City of Portland Design Commission

Design Advice Request

SUMMARY MEMO

Date: 10/22/2024
To: Garrett Helm | Bora Architecture & Interiors
From: Tanya Paglia, Design & Historic Review Team
503-865-6518 | Tanya.Paglia@portandoregon.gov
Re: EA 24-067517 – Ida B. Wells Modernization
Design Advice Request Commission Summary Memo – September 19, 2024

SITE PLAN - SCHEMATIC DESIGN

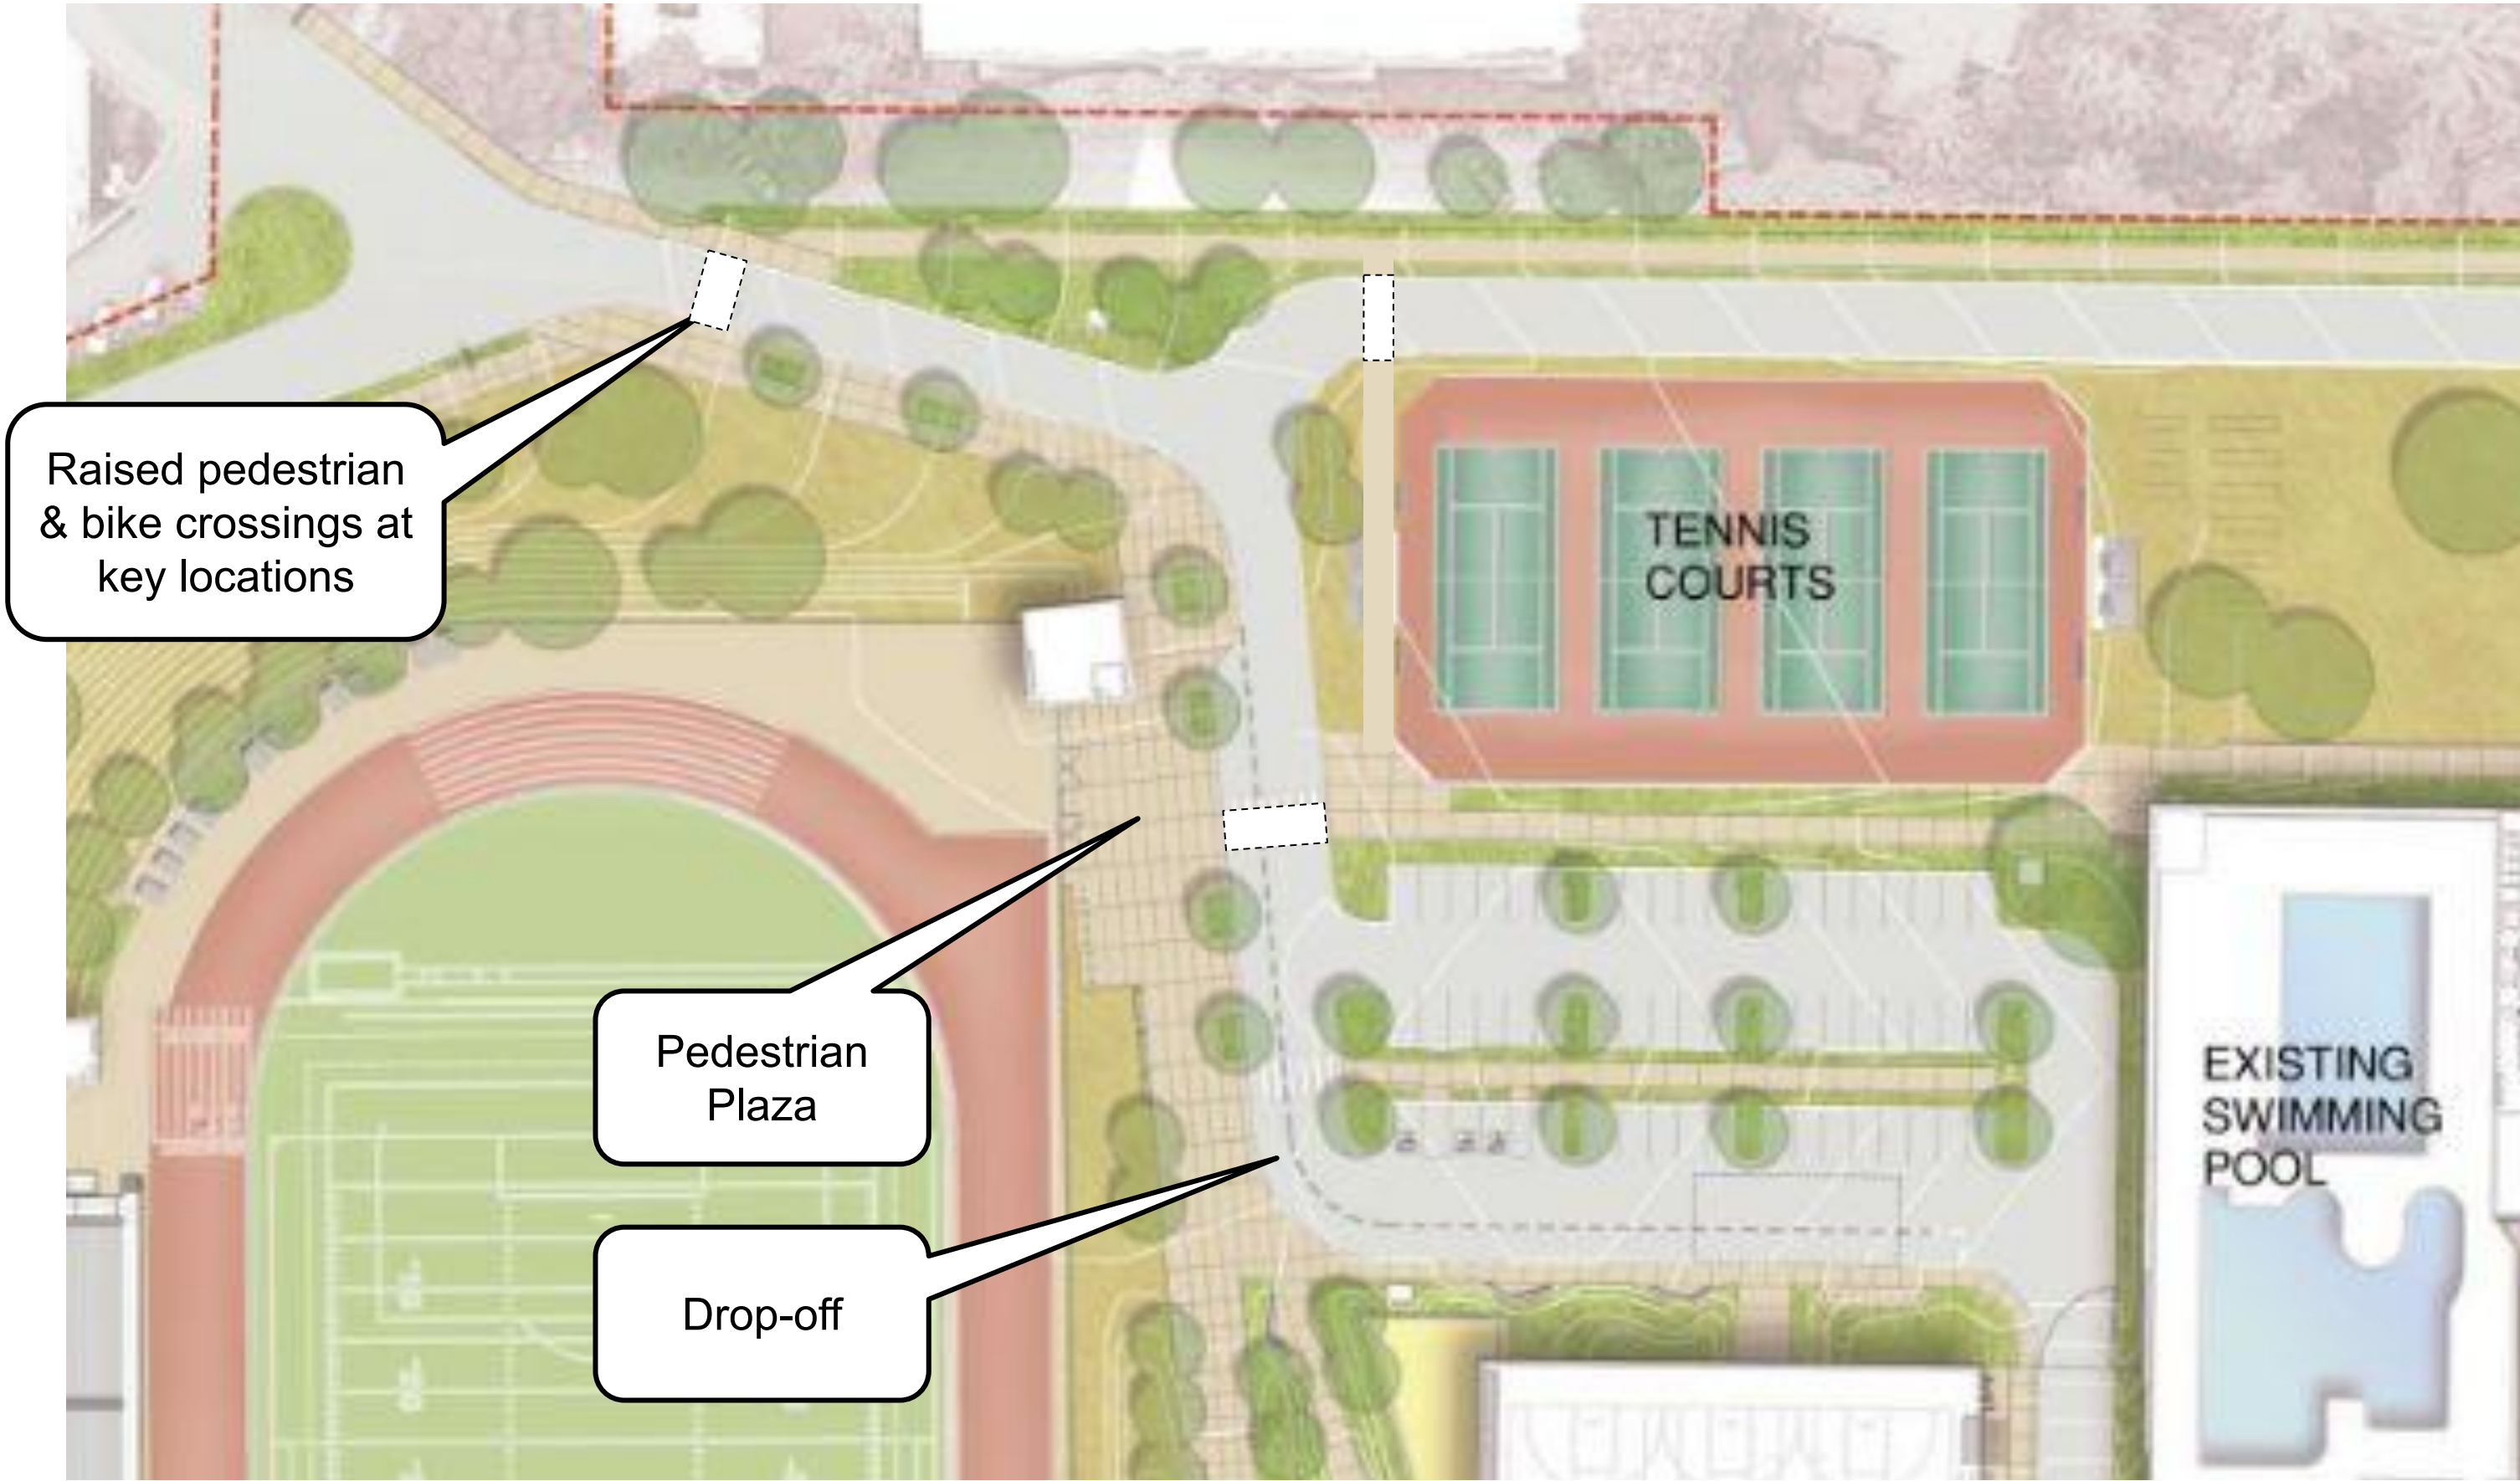
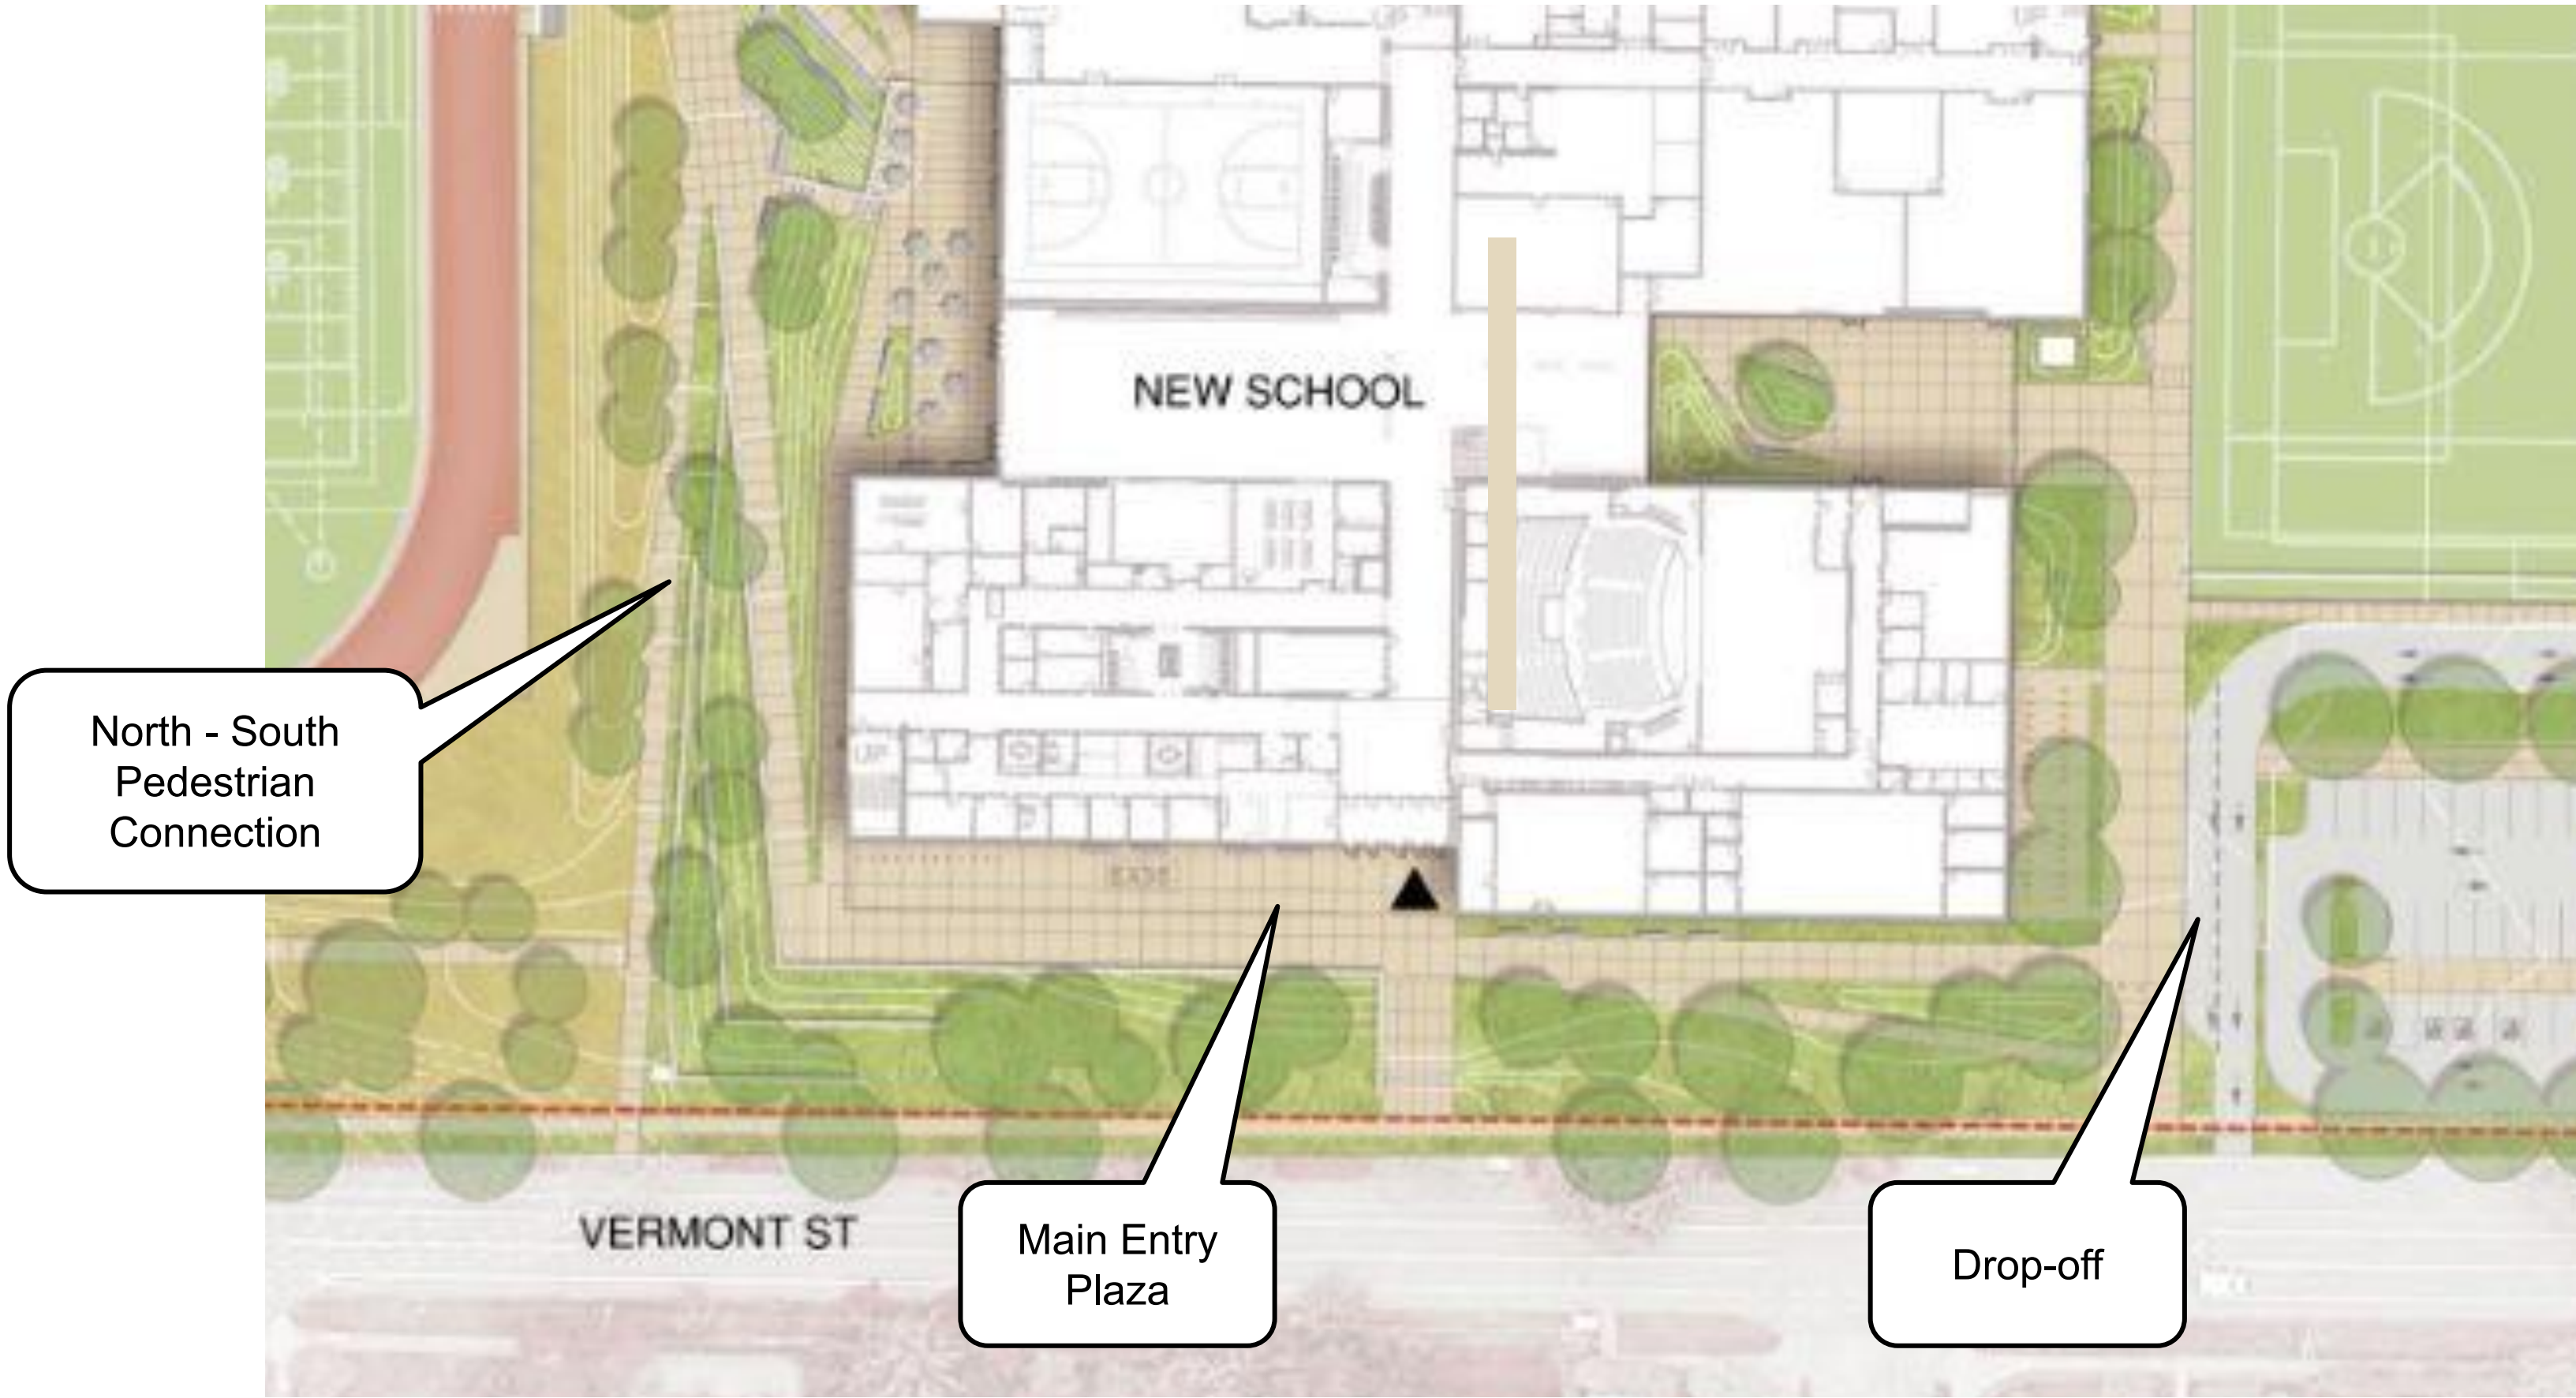
- General support for the project as an improvement to the school campus experience.
- Rework the north campus approach to create a sense of place and safely channel pedestrians and cyclists to the main building entrance at the south side of the site via the north-south pedestrian connection.

- Support for locating grandstand on the west side of the track and field.
- Reconfigure the pool parking lot driveway to improve bike/ped safety at the north end of campus and to avoid breaking up the north-south pedestrian plaza/walkway.

- Outdoor gathering spaces are heading in the right direction, including the central north-south pedestrian plaza, although refinement is needed at the northern end.
- Detailed plans on outdoor gathering spaces including landscape and hardscape plans, etc. would be helpful as would a diagram of the entrances and egresses of the building and their relationship to the pedestrian plazas and connections.

FLOOR PLAN ORGANIZATION

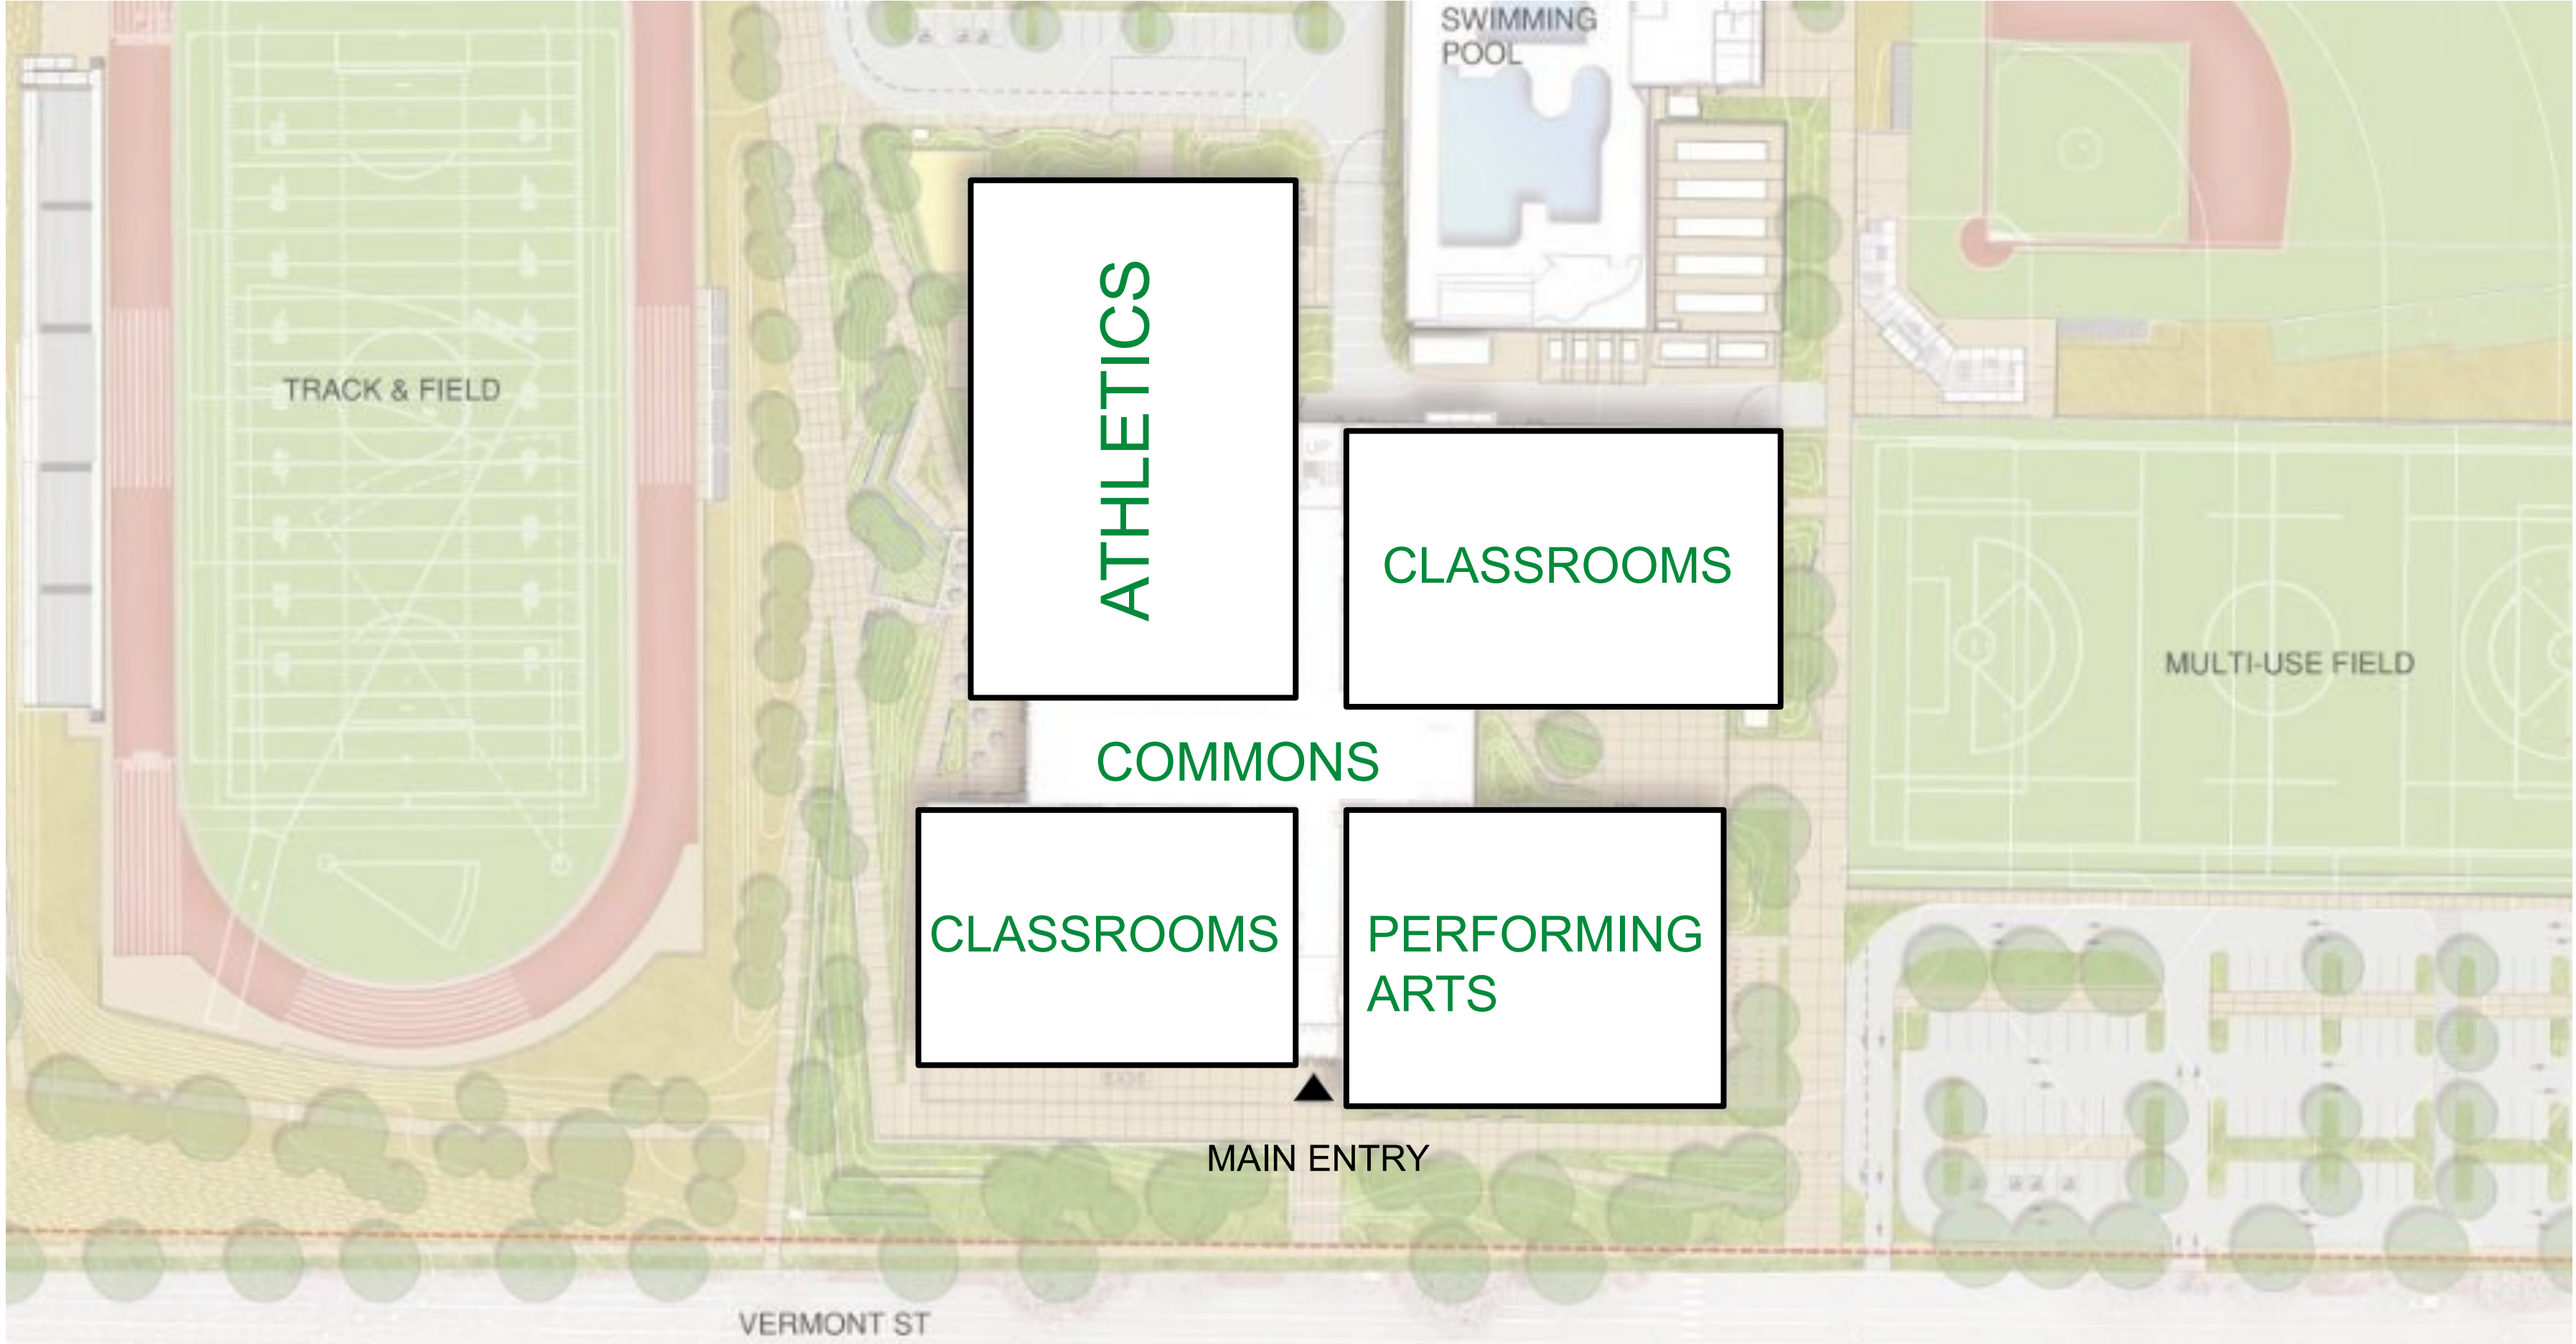
- Placement of the bars is working well, and façade studies look on track. The colonnade at the front is a plus.
- Plan/diagram of building looks great – commons at the center creates views out and makes the building readable to people inside it. The four equal quadrants are good.
